STAFF RECOMMENDATION
3614 Richland Avenue
Lot 15, Richland Hall Development
November 15, 2017

Application: New construction—infill and outbuilding
District: Richland-West End Neighborhood Conservation Zoning Overlay
Council District: 24
Map and Parcel Number: 10409008800
Applicant: Chad Gore, Mike Ford Builders
Project Lead: Jenny Warren, jenny.warren@nashville.gov

Description of Project: Application is to construct a new single family infill and an outbuilding.

SITE PLAN

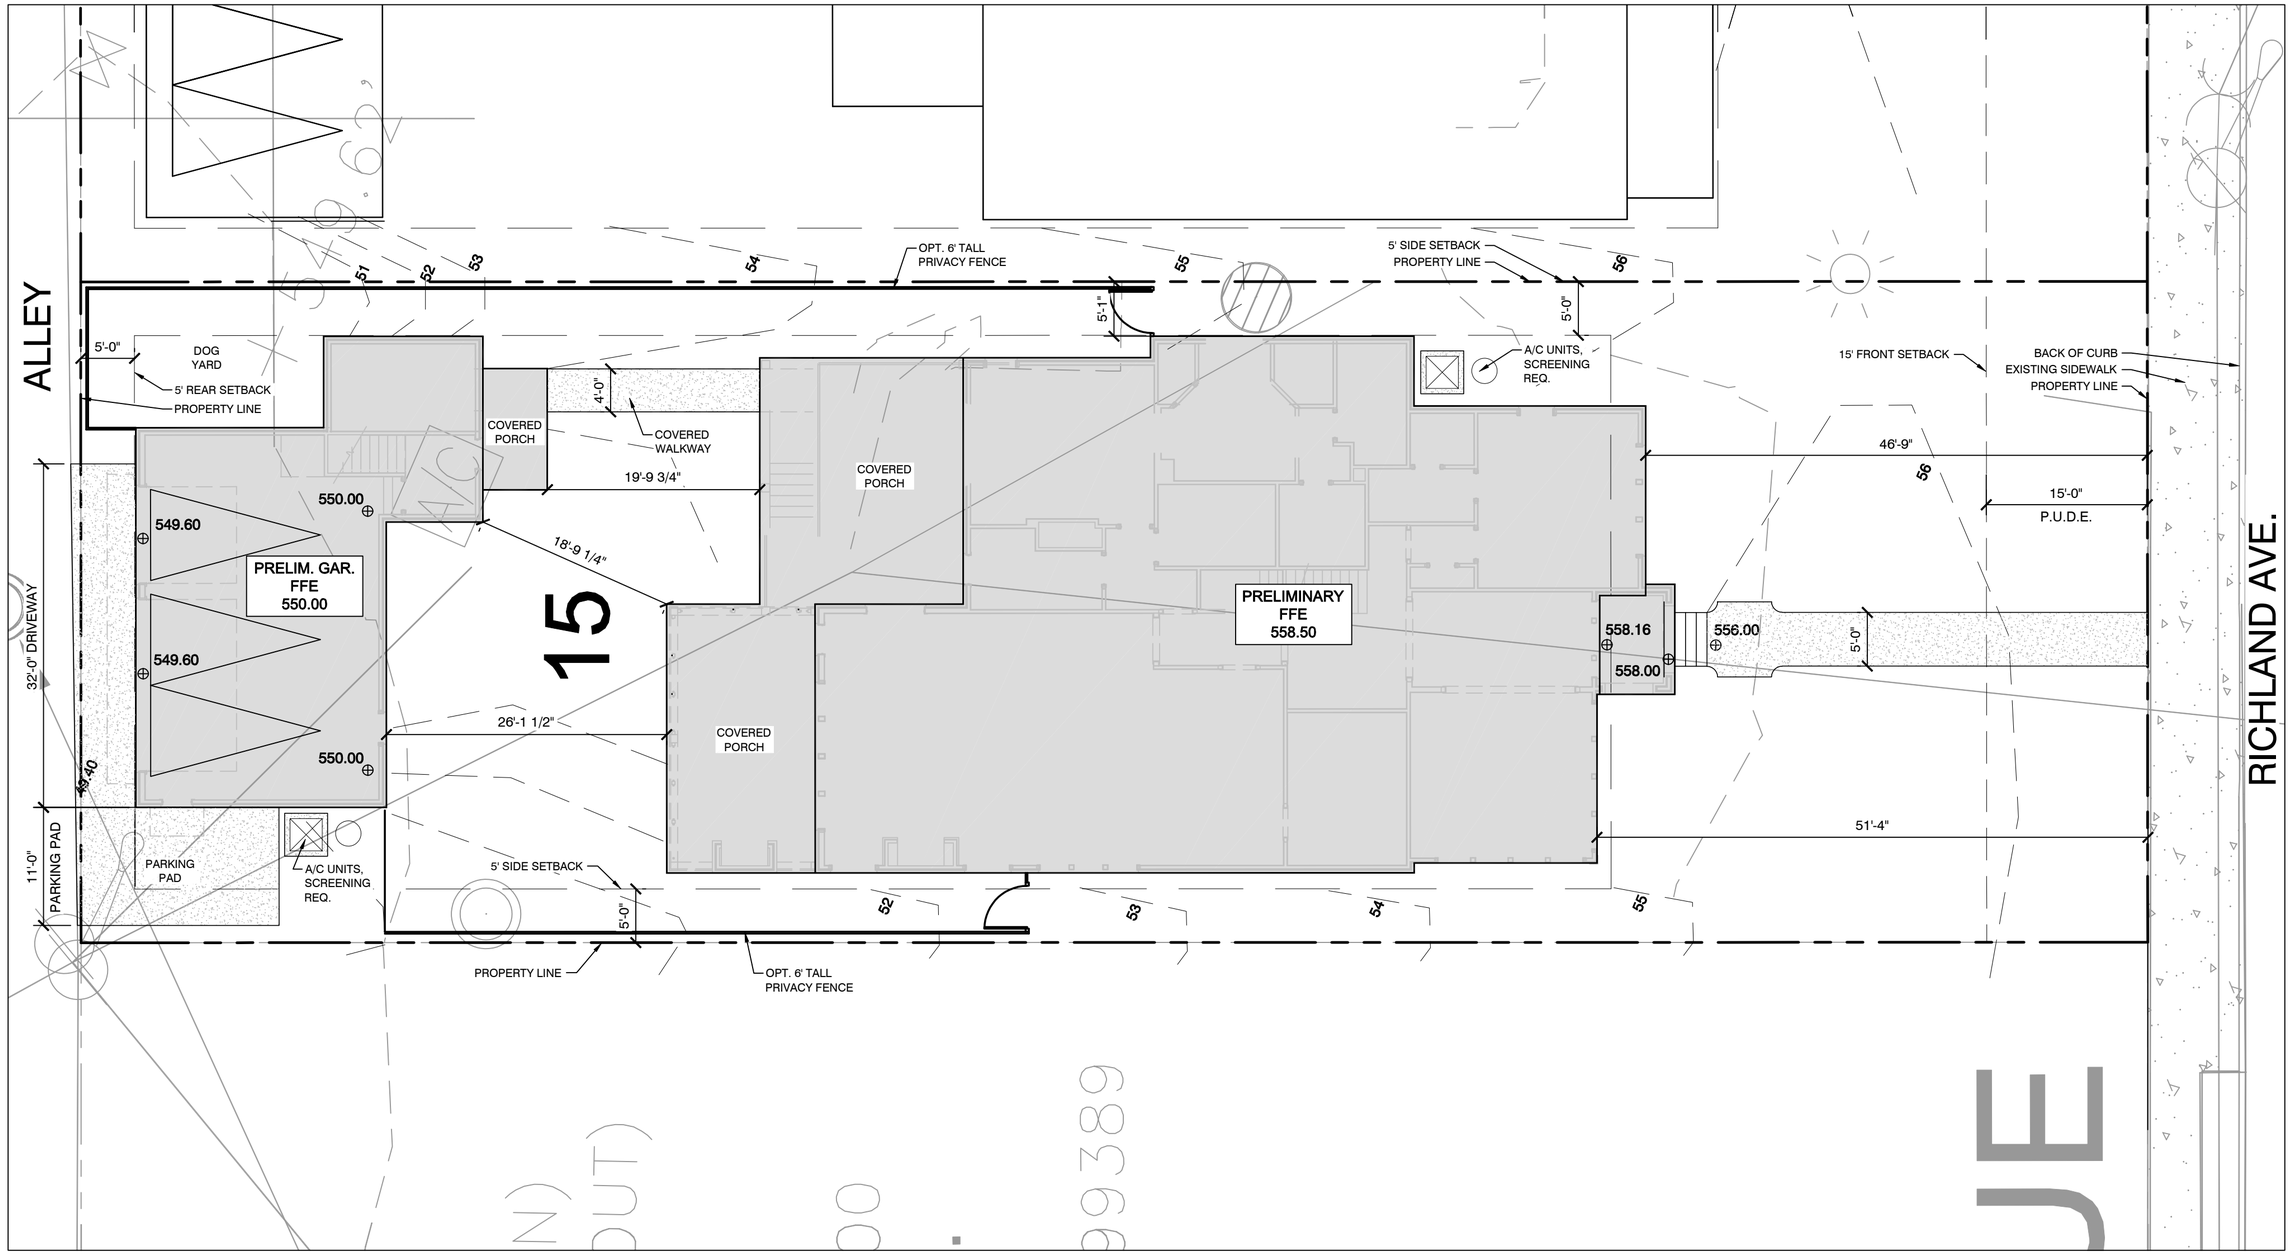
Setback & Rhythm of Spacing: The proposed infill will meet all base zoning setbacks. The proposed front setback for this house is forty-six feet, nine inches (46'9) on the right side and fifty-one feet, four inches (51'4") on the left side. The front setback for this development is intended to line up with the historic house at 3618 Richland Avenue, which is thought to be approximately fifty to fifty-five feet (50'-55'). Staff recommends that the infill be situated so that the portion of the house closest to the front sidewalk lines up with the historic setback found at 3618 Richland, to be verified by MHZC in the field. (The front porch would be permitted to extend closer.) Pushing the house further back on the lot may reduce the distance between the back of the house and the outbuilding. Staff recommends that the distance between the two structures be no less than nineteen feet, nine inches (19'9").

The infill will meet the five foot (5') side setback requirements on both sides. It will be over fifty-three feet (53') from the rear property line. With the condition that the infill be situated so that the right side of the house lines up with 3618 Richland Avenue, Staff finds that the proposed setbacks to be similar to the immediate historic context and to meet Section II.B.1.c. of the design guidelines.

fifteen feet (15') from the front wall of the house. Staff requests that this unit be relocated either to the rear, or past the mid-point on either side elevation. With these conditions, Staff finds that the infill meets Section II.B.1.i. of the design guidelines.

1. The finished floor height be consistent with the finished floor heights of neighboring historic houses, to be verified by MHZC staff in the field;
2. The infill be situated so that the portion of the house closest to the front sidewalk lines up with the historic setback found at 3618 Richland, to be verified by MHZC in the field;

3. The distance between the infill and the outbuilding be no less than nineteen feet, nine inches (19’9”);
4. Staff approve the stone sample prior to purchase and installation;

5. Staff approve color and texture of the asphalt shingle and metal roof;
6. The HVAC unit be located behind the house, or beyond the midpoint of the house;

FINLEY RESIDENCE
LOWER LEVEL PLAN

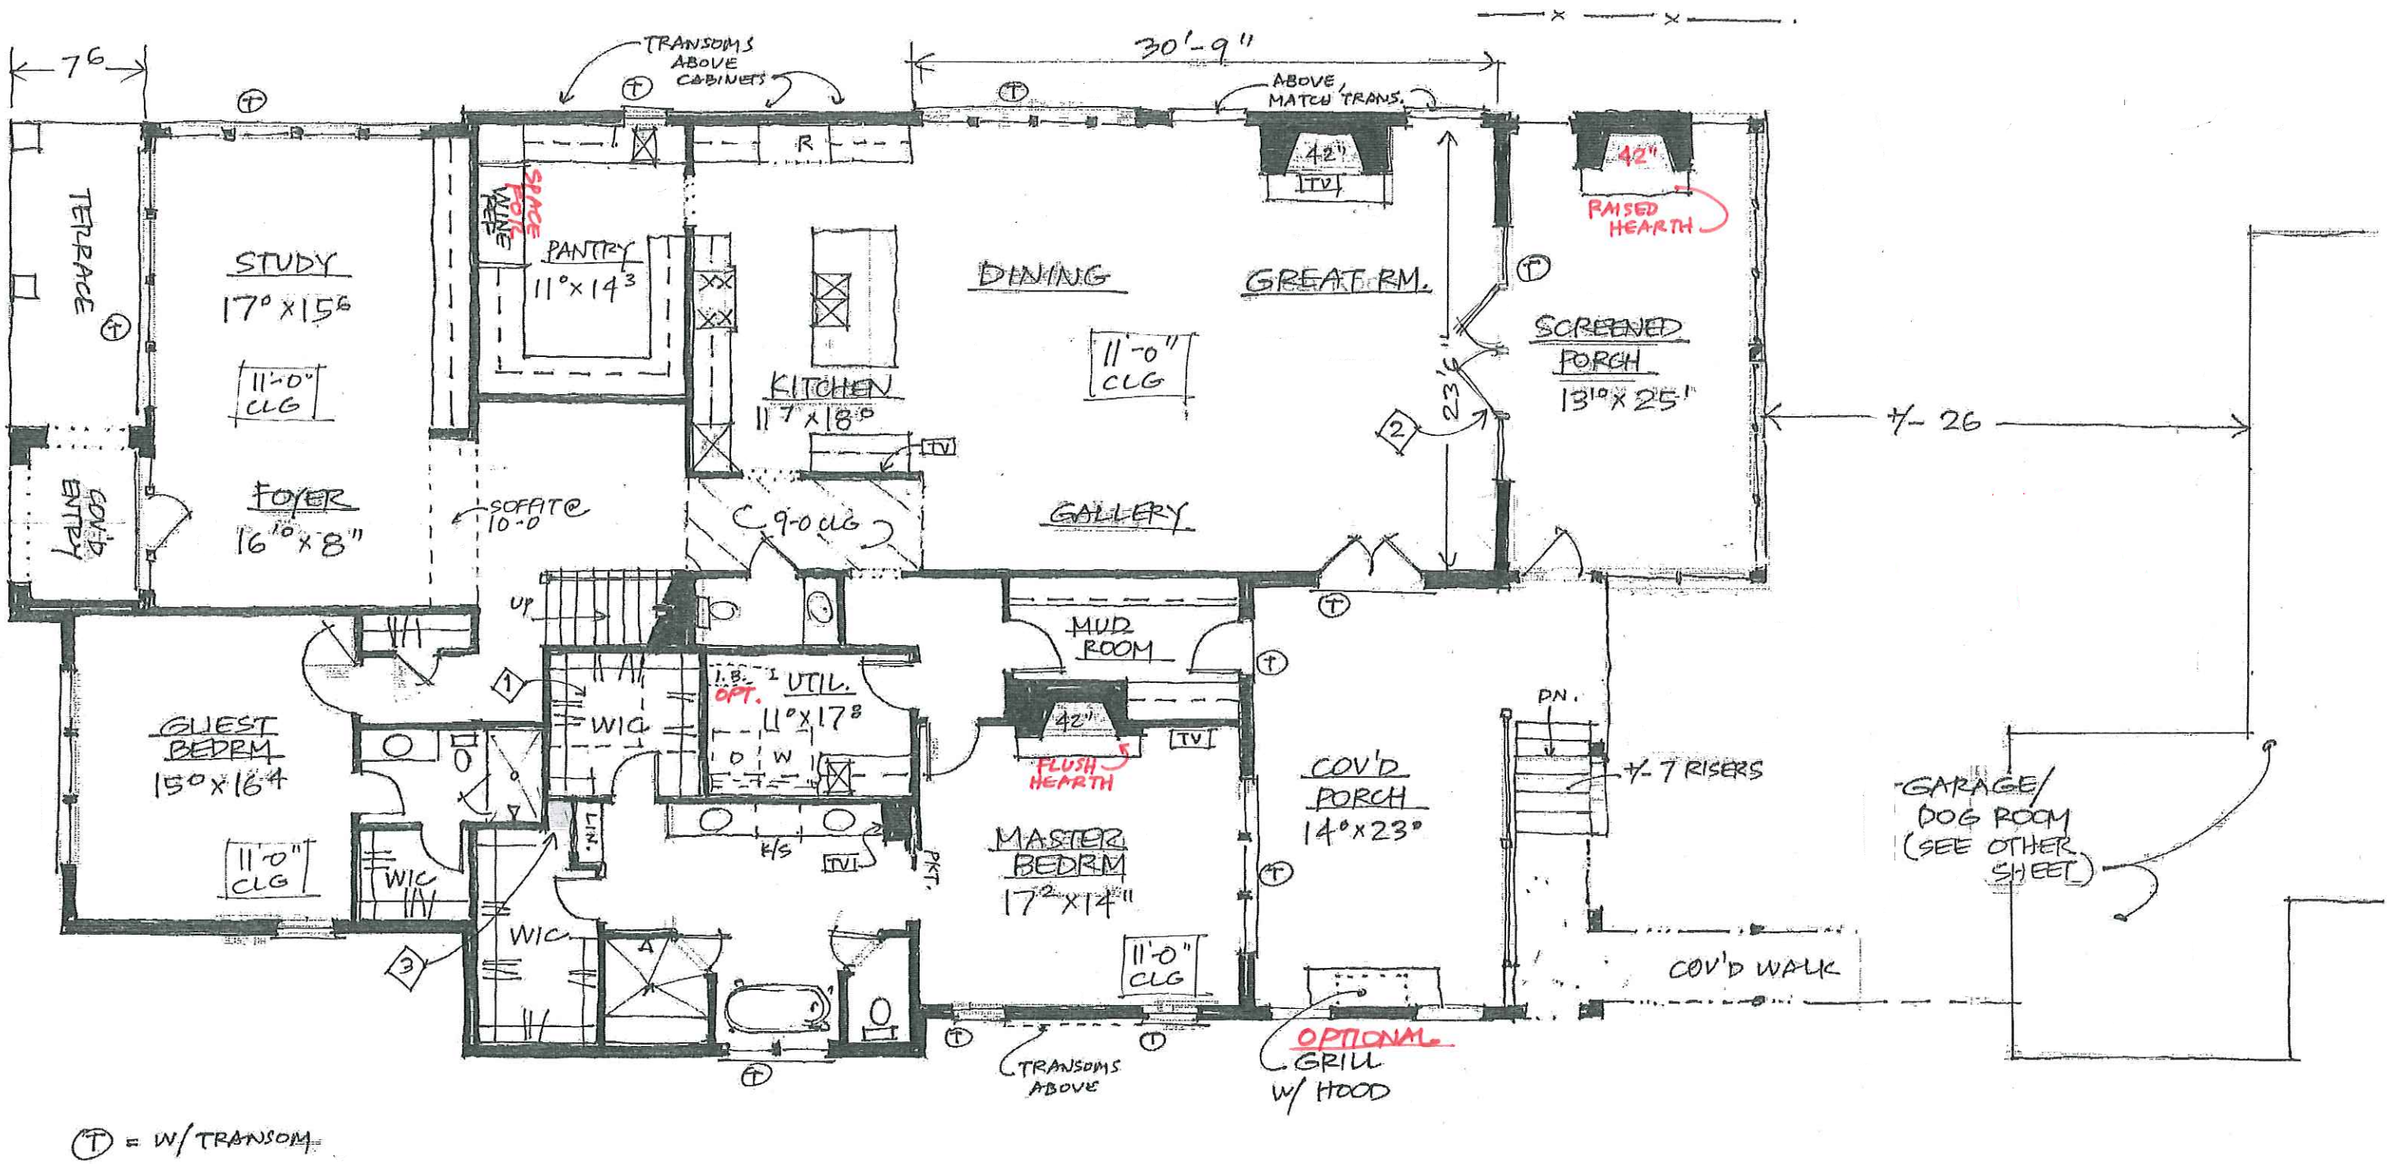
The lot is approximately sixty-two feet (62’) wide. The house will be approximately forty-two feet wide (42’) wide at the front. It expands to be forty-eight feet wide (48’) wide at a distance approximately twenty-three feet (23’) back from the front. Staff finds that the wider portion of the house is appropriate because it sits back significantly from the front plane of the house. In addition, the proposed width is similar to what was approved on Lot 1, which is a sixty-six feet (66’) wide lot and has a width at the front of forty-three, nine inches (43’9”) and a maximum width of forty-eight feet (48’). It is also within the range of the widths of the historic houses in the immediate vicinity, which range from thirty-eight to sixty-five feet (38’-65’).

Appurtenances & Utilities: The proposal includes a covered walkway from the garage to the house, which the Commission has approved in the past. The materials of the driveway at the rear, the covered walkway from the house to the garage and the walkway leading to the front porch from the sidewalk are not indicated and should be approved by Staff. Fencing is indicated on the site plan, but again the material is not indicated, Staff needs to approve this material as well. The HVAC unit is proposed to be only about

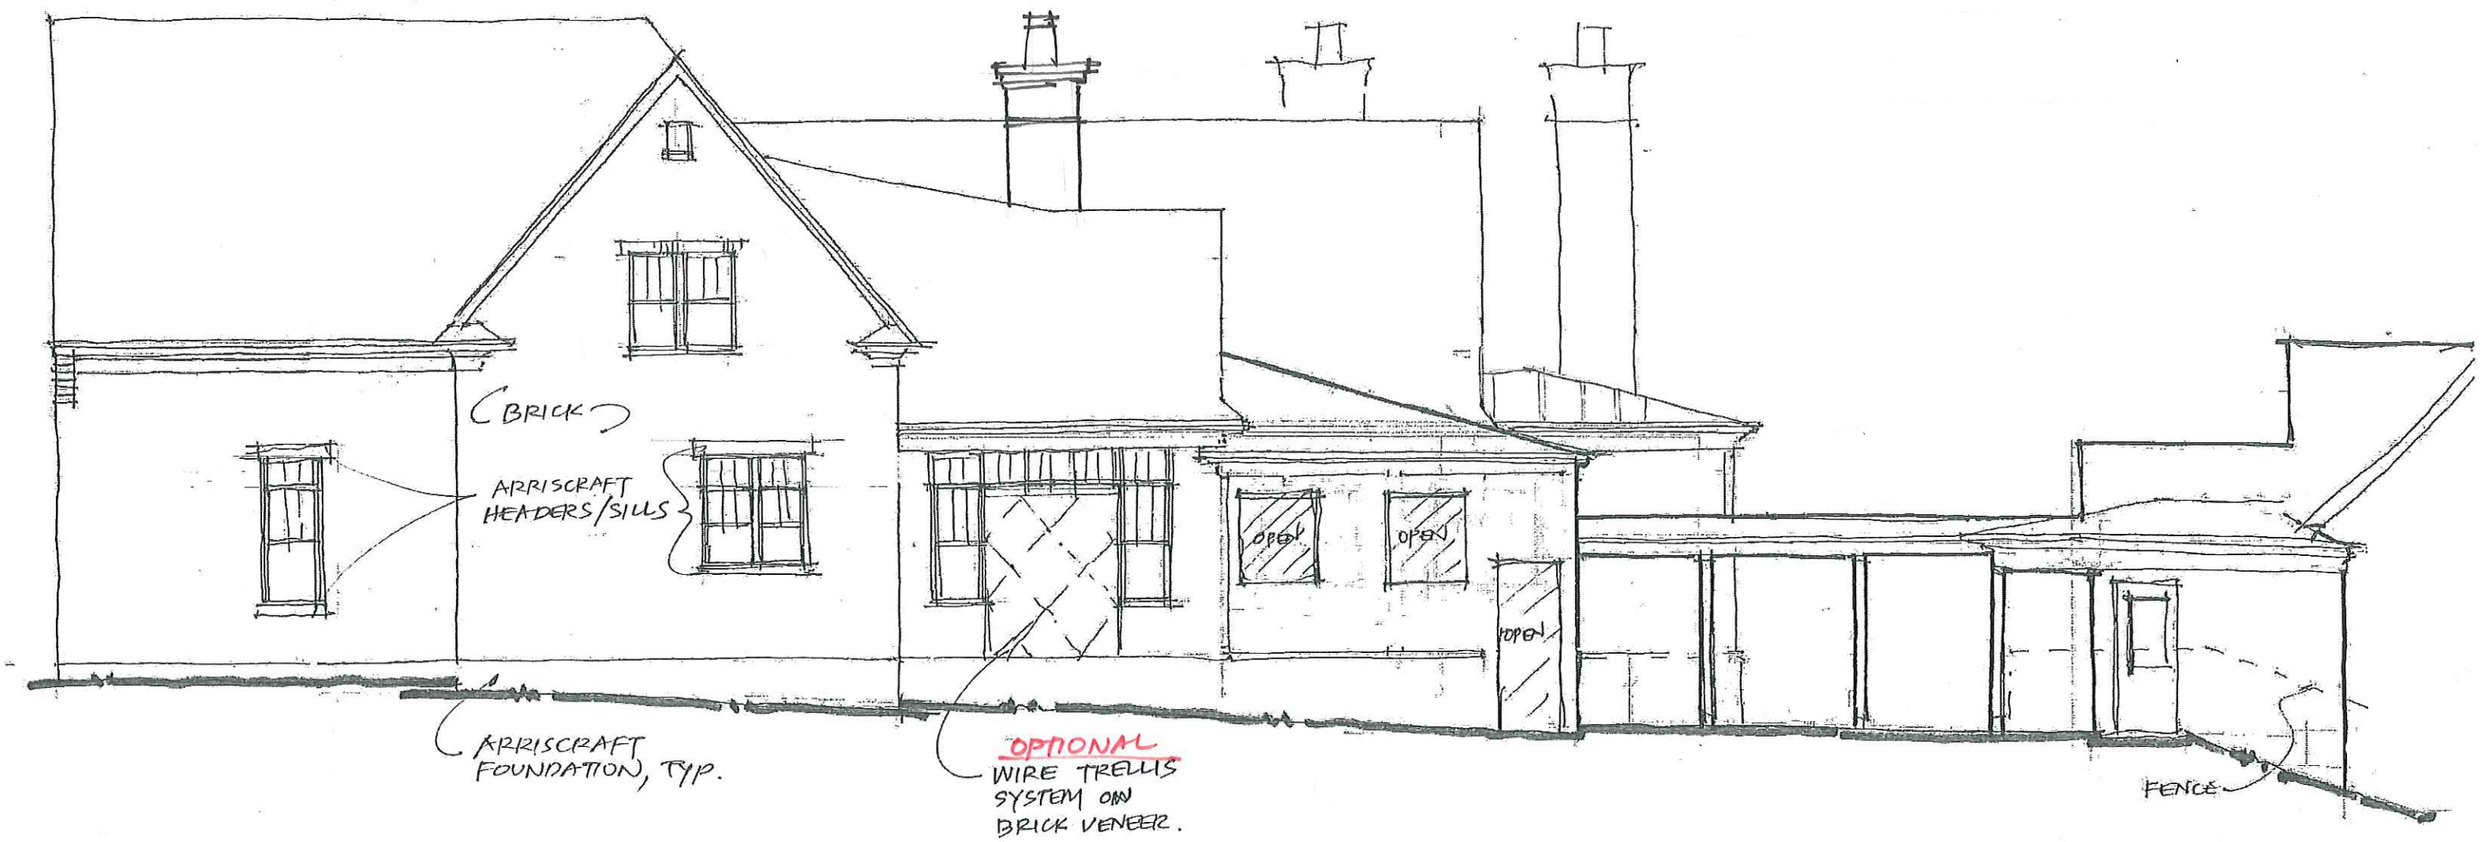
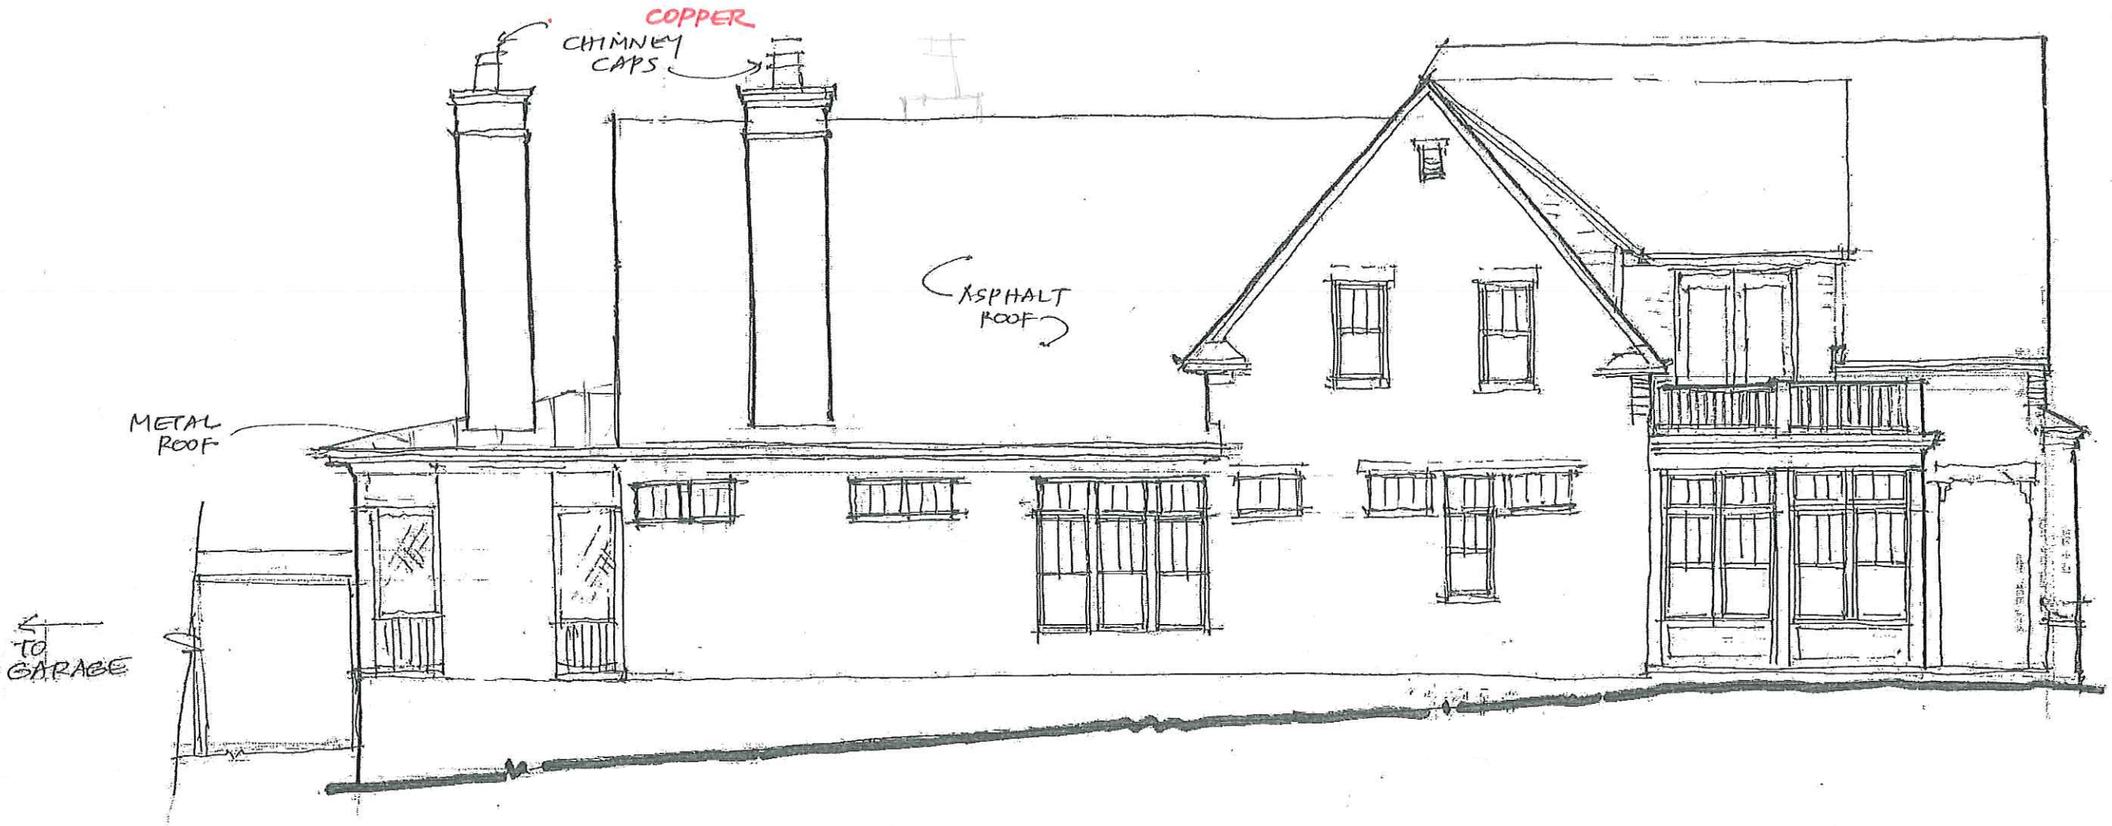
<u>Height & Scale</u>: The proposed infill will be two stories, with a maximum height of thirty-two feet, six inches (32’6”) above the foundation at the front, and approximately thirty-five feet (35’) above grade. The infill will have an eave height of eighteen feet (18’) above the grade at the front. The foundation height will vary due to grade, but will be approximately twenty-four inches (24”) at the front. Staff finds that the proposed height is similar to the heights of historic houses in the immediate vicinity, which range from thirty to forty-four feet (30’ – 44’). It is also in keeping with what has been approved in the past for the infill houses in this development.

Roof form: The infill's primary roof form is a cross-gabled roof with a steep 14/12 pitch on the front, side and rear elevations. A shed dormer on the front elevation is inset two feet (2') from the main wall and has a slope of 6/12.

Proportion and Rhythm of Openings**:** The proposed windows on the infill are generally twice as tall as they are wide, thereby meeting the historic proportion of window openings. There are no large expanses of wall space without a window or door opening All window groupings have a four to six inch (4"-6") mullion in between the individual window openings. On the side elevations, there are several windows that are long and narrow, Staff finds them to be appropriate, however because the majority of them are over forty-five feet (45') back from the front of the house and because they are used sparingly. Staff finds that the infill's proportion and rhythm of openings meet Section II.B.1.g. of the design guidelines.

7. Staff approve the materials for the porch floors and stairs, the rear porch columns, the driveway, walkway and fencing;
8. Staff approve all window and door selections prior to purchase and installation;
